# Change Notice

# IS Series

## Changes for OLED Module & Driver IC in SmartSwitch Rocker

# Contact No. 340

SmartSwitch Rocker Changes for OLED Module & Driver IC

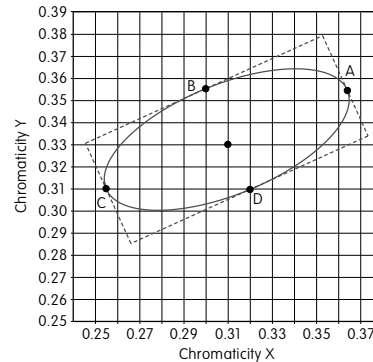
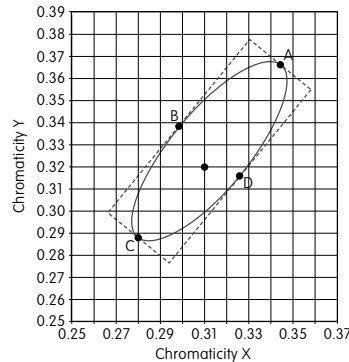
The IS Series Rocker will have a different OLED module and driver IC. This revision will effect standard and custom rockers, including any assembled in the IS Development or Engineering Kits. The standard part number is shown below. Tables depict the various specification differences before and after the change to the new module and IC driver.

**Power ON/OFF Sequence**

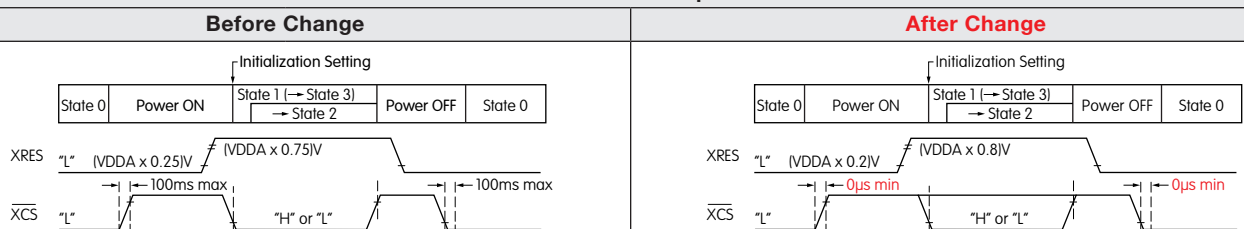
Some of the command parameters are changing. Refer to the data sheet on the website for the most recent information.
